MILLVILLE PLANNING COMMISSION MEETING

5.A. Consideration for approval of the Mond-Aire Heights Subdivision preliminary drawing. The subdivision is located East of 400 East to 550 East, and North of Center St. to 200 North in Millville.

MEMORANDUM

SUBJECT: Mond-aire Heights Subdivision

MOND
PRELIMINARY PLAT
AND-AIRE HEIGHTS SUBDIVISION
 MILLVILLE, CACHE COUNTY, UTAH
 PART OF THE WEST HALF OF THE NORTHWEST QUARTER
 OF SECTION 23, TOWNSHIP 11 NORTH, RANGE 1 EAST
 SALT LAKE BASE AND MERIDIAN

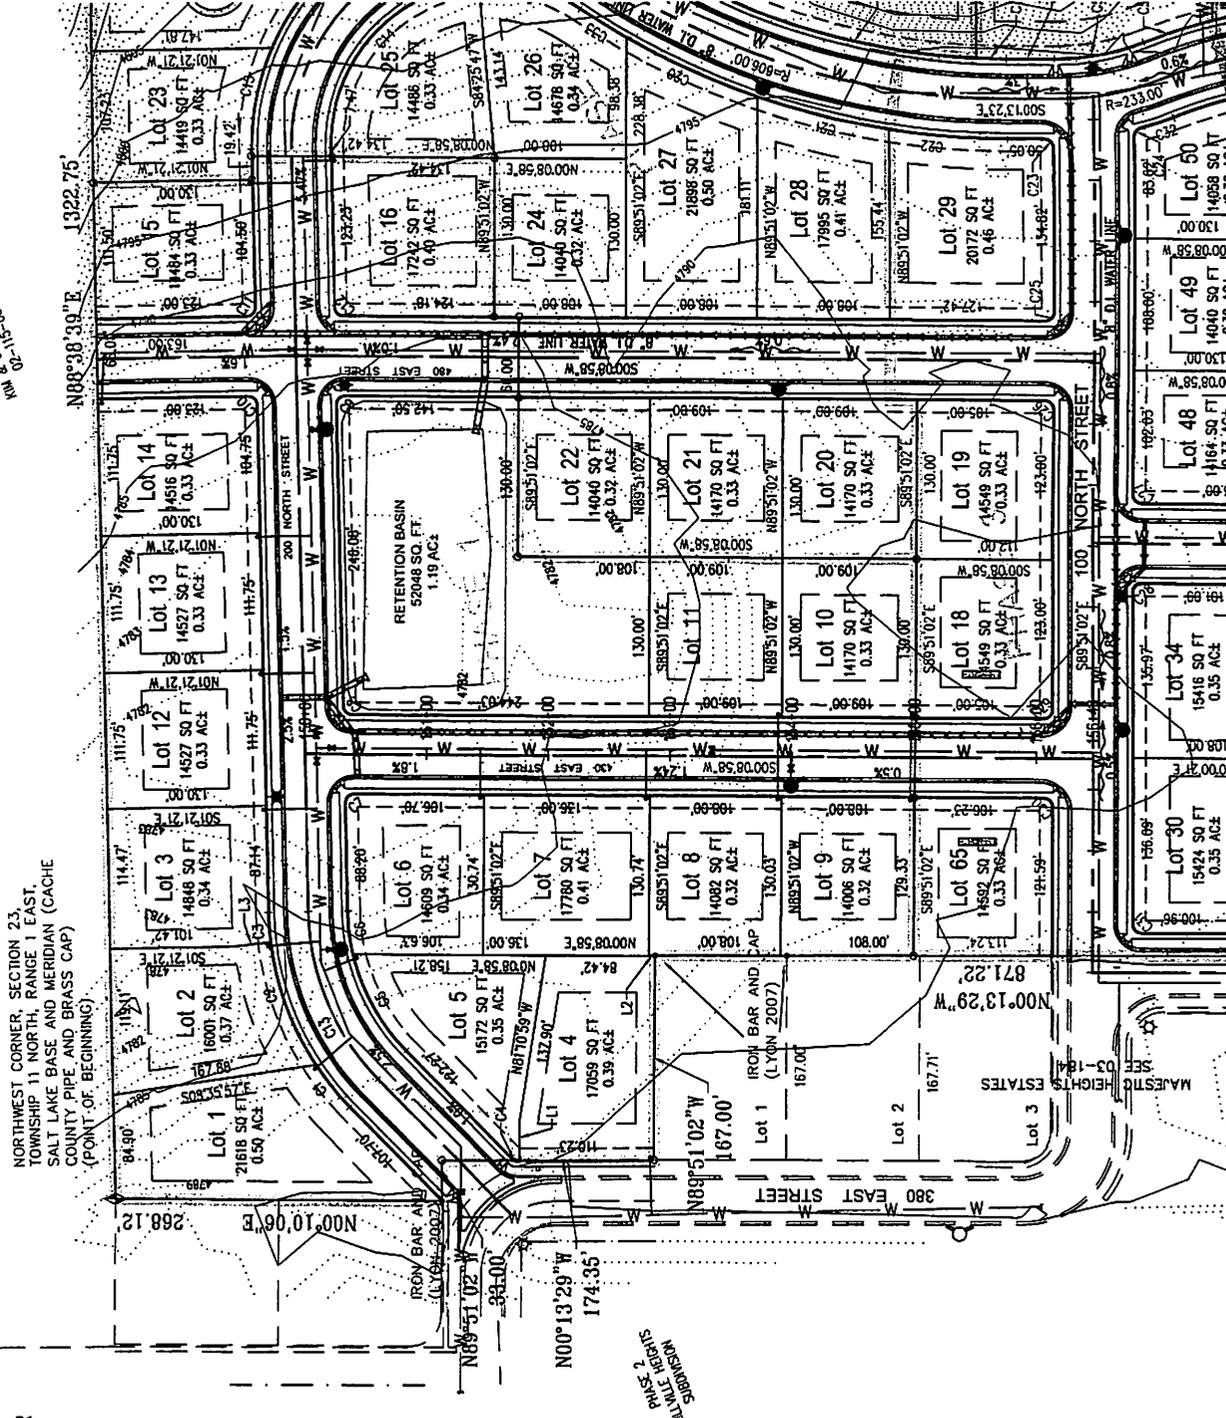
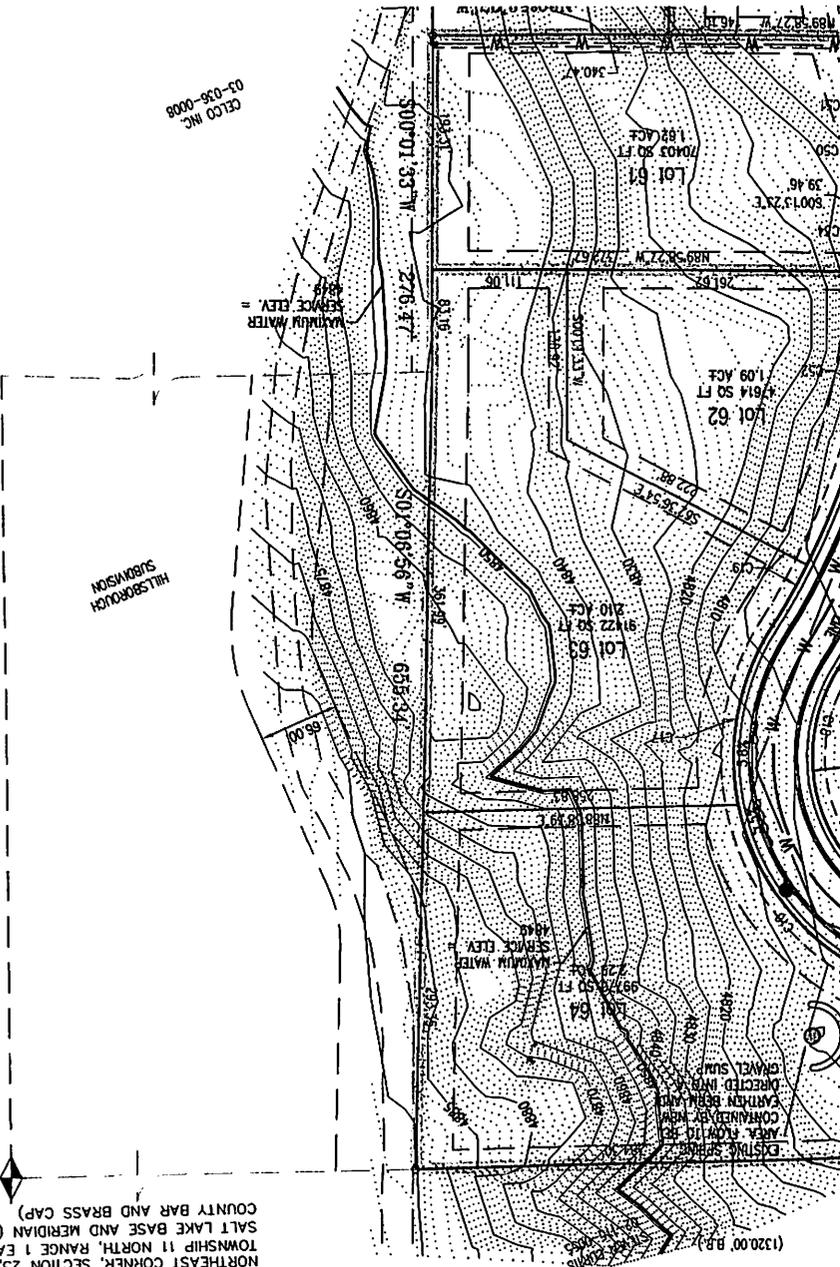
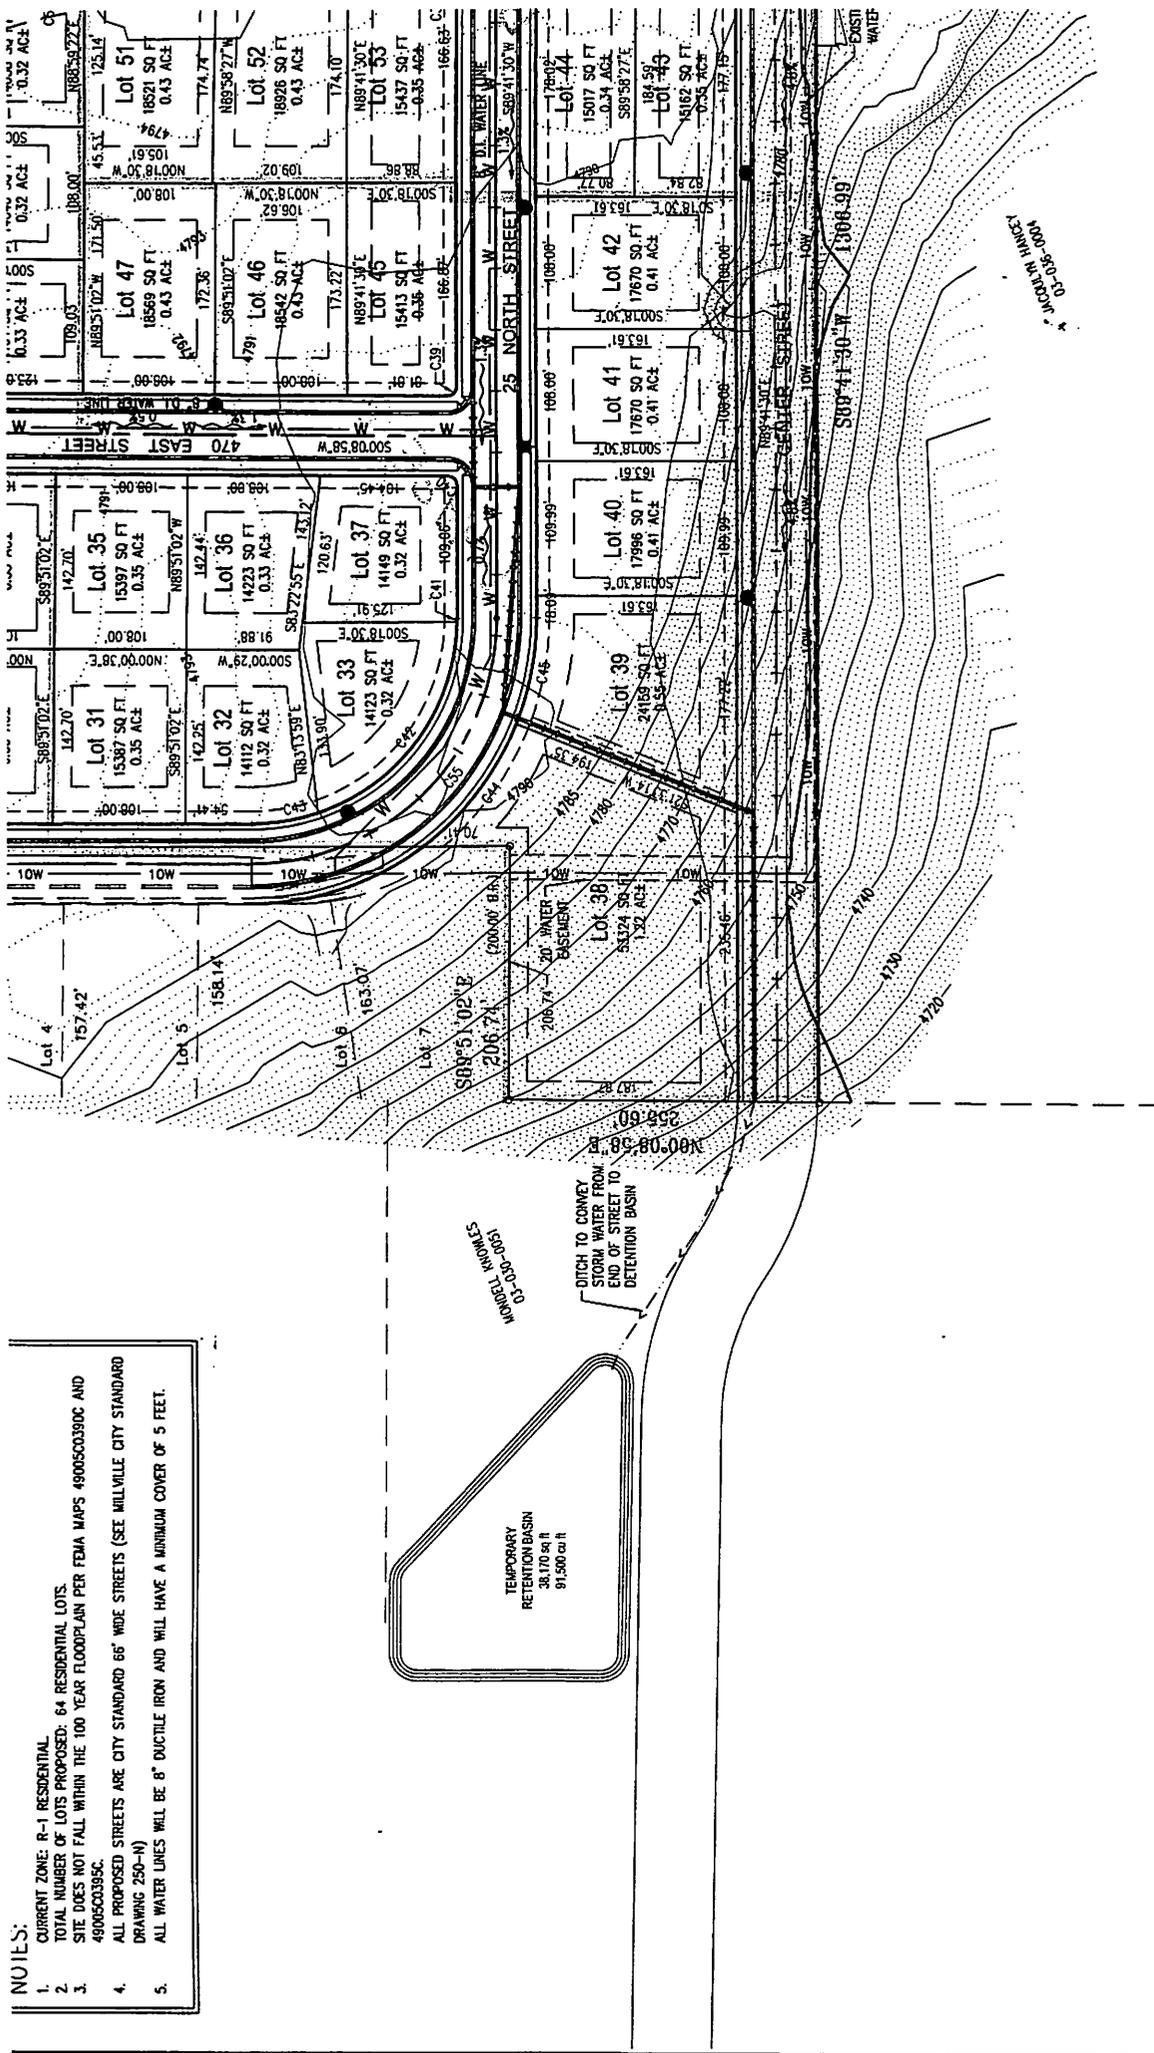
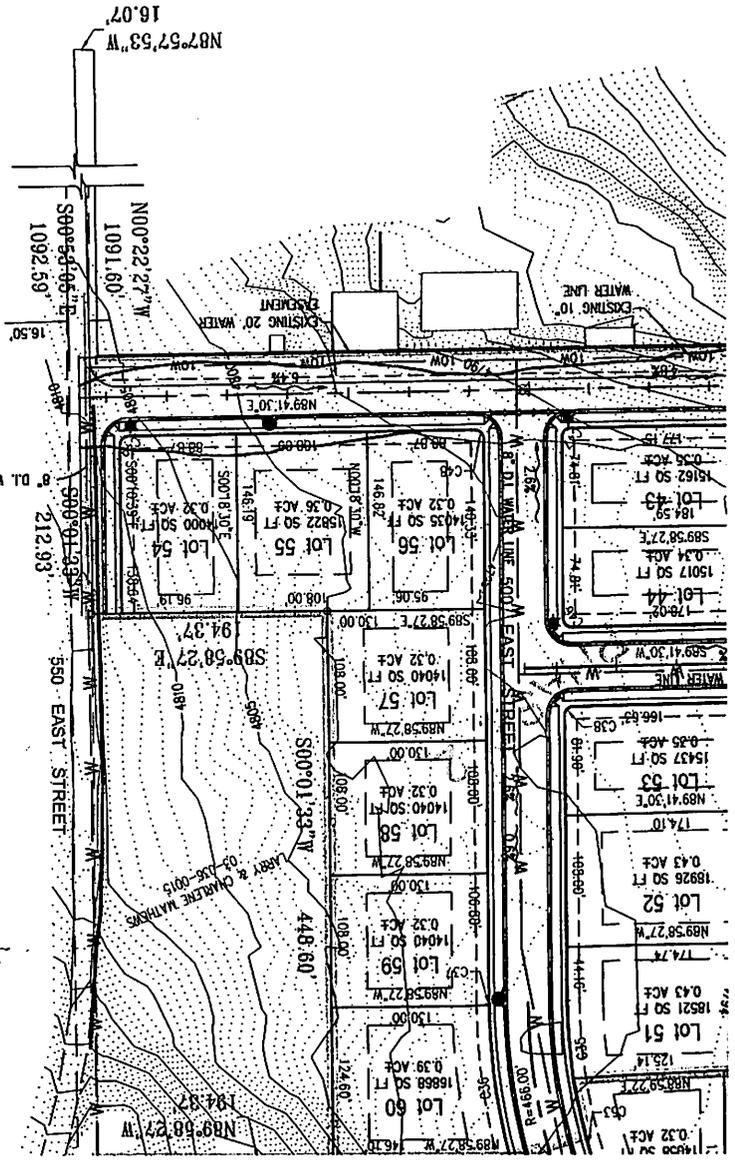
The preliminary plat has the following label: DITCH TO CONVEY STORM WATER FROM END OF STREET TO DETENTION BASIN.

This should be changed to RETENTION BASIN. As a retention basin has no release.

On the Plat drawings the road that curves off of 380 East is not labelled and should be listed as 400 East.

1. The name of the developer is not show on the plat. -Done
2. The contours on the drawing are not labeled. - Done
3. Provisions of the Hillside Development Overlay will need to be followed to receive final approval. – **There are still issues with the Hillside Overlay Ordinance. Lot 39 does not comply with the ordinance as the subdivision is currently laid out and roadways designed. I have discussed some of the potential ideas with the developer’s engineer. They are discussing alternatives.**

1. The map and the legal description do not match on Course S. 01°06’56”W. on the westerly side of the boundary. The map has a distance of 655.34 feet while the legal shows 655.37 feet. It does not close. – **The boundary closes now.**
2. Several Lots do not have enough information to check closure.
 - a. Verify closure on Lots 8, 10, 30, 31, 32, 33, 34, 35, 36, 37, 51, and 52. - Done
 - b. Missing curves C33 on Lot 50 and C52 on Lot 62. Cannot verify closure of these Lots. - Done
 - c. Missing easterly distance on Lots 7, 17, 33, 48, 49, 57, 58, and 63 (2). -Done
 - d. Missing northerly distance on Lots 21, 22, 39, and 54. - Done
 - e. Missing westerly distance on Lots 26, 57, and 61. - Done
 - f. Missing southerly distance on Lot 63. - Done
 - g. Missing bearing for back Lot line for Lots 30 to 36. Assumed to be same as 470 East Street. - Done

1. 150 foot curve on the east end of the subdivision is sharper than the standard allows. - **Done**
2. Center Street has cuts of up to 13 feet into the north hillside next to the sidewalk. A retaining wall or grading will be required. Items to address this should be included on the preliminary plat. This will also affect the Hillside Overlay requirements. **See item 3 above.**

3. There are existing structures on the south side of Center Street that will interfere with construction of a full 66' right-of-way. The road should be shifted to have the full 66' right-of-way on the development. There may be a payback agreement created for the adjacent property owner if they utilize the road at a future date. – **The road has been shifted.**

4. The curves west of the development on Center Street appear sharper than city standard allows. – **These are only visual at this time and will be corrected in final design of that property.**

5. There should be a roadway dedication on the north and south end of the project where the property is adjacent to 550 East. – **The south end of the project has the dedication included in the plat. The north end of the project already has a 66 foot right of way in Providence, therefore the dedication there is not needed.**

1. The spring in the NE Corner of the property is likely a wetland. Any alterations to the spring will need to be approved by the Corp of Engineers. – **This is noted on the plans**
2. The outfall from the drain to Center Street shows no connectivity to the temporary pond. Please clarify if this will be connected via a pipe or ditch. – **This will be completed in the final plans**
3. There appears to be several bubble up boxes in the development. These are not allowed in the City. See 8.05.B of the MDCS. – **The bubble up boxes have been addressed.**
4. The sump in 420 East will need to be abandon and drainage incorporated into this project. - **Done**

1. The final grade of the waterline in Center Street should be confirmed in final design so cover over the pipe is not affected by the final road grade. - **This will be completed in the final plans**
2. The approximate maximum water service elevation for the area is 4849.00. This service limit is along the east side of the property and should be shown on the plan. - **Done**

3. The waterline along 550 East should be extended to the intersection with waterline at approximately 90 North. Any easements will need to be obtained so the line can be installed and maintained. - **Done**
